Ventura County Medical Center Expansion Replacement Clinic

Final
**Supplemental
Environmental
Impact Report**

September 2017

Photo 1 - Provided by commenters

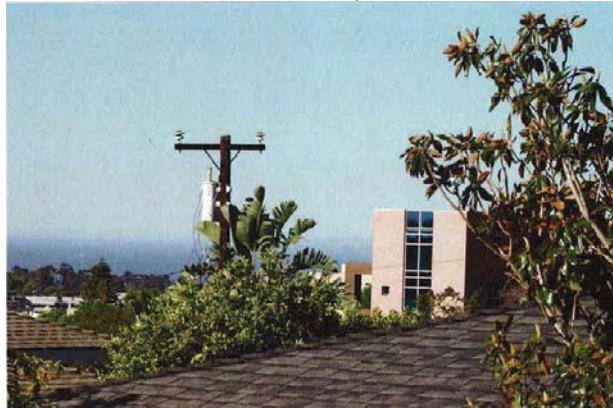
except for a partial narrow view of the ocean from a specific viewpoint, views of the Clinic building are generally blocked by existing buildings or trees. Photo 1, provided by commenters, was noted to be taken from the same location as the photo simulation provided on page 34 of the final SEIR that illustrates impacts to Lynn Drive. The difference between Photo 1 and the photo provided on page 34 is that the Photo 1 is zoomed in from the view available from the street and taken at a slightly different angle. A field visit was done on July 11, 2017 by Rincon Consultants in attempts to re-create the same view as seen in Photo 1, however, the best view available from Lynn Drive was still comparable to the photo provided on page 34 of the final SEIR and the exact view and angle in Photo 1 could not be recreated. See comparison below.

Figure 1a&b: Photo Area on Lynn Dr. – showing location of impacts from public street.

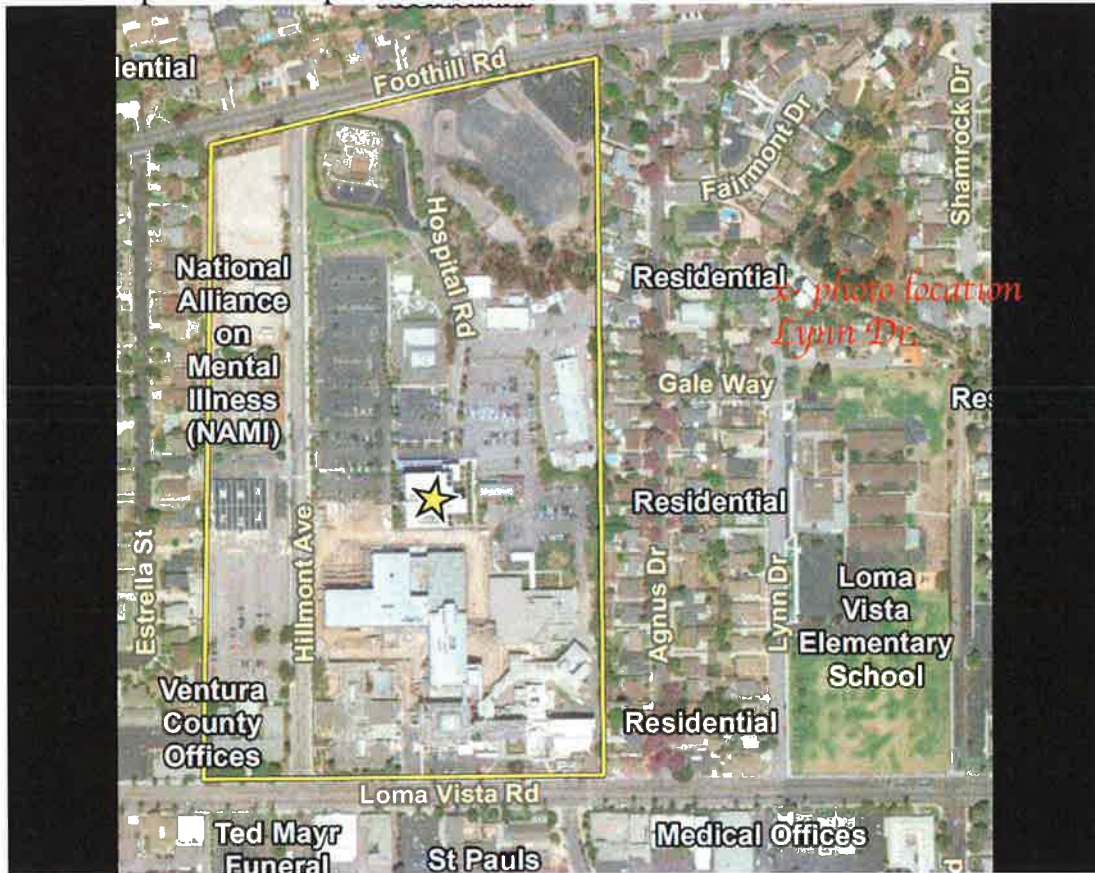
10.7
cont.

Photos from Lynn Dr. :

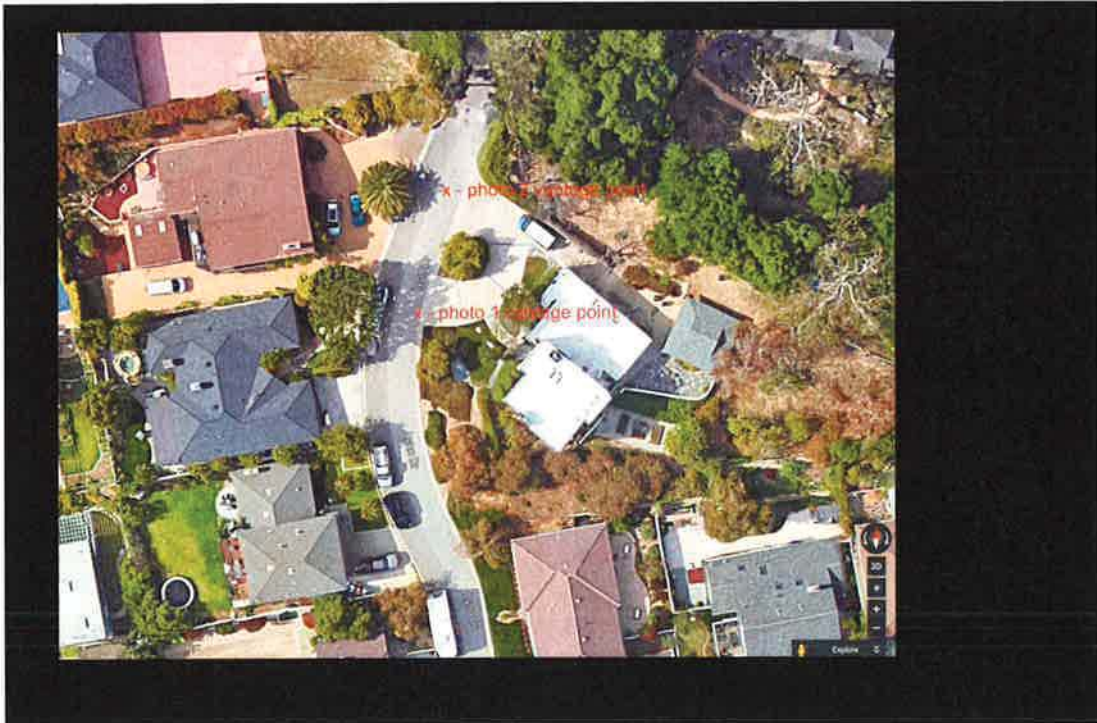
Photo 2: Taken from another location on Lynn Drive~ Shows the additional height of the Clinic Building in the view shed from this street. (The tree in the foreground was planted strategically by Jackie Moran to help reduce light pollution and aesthetic impacts from the Clinic Tower on this residential street. The view of the ocean and island is still impacted regardless of the tree from the public street (you can see through the tree to the Ocean)
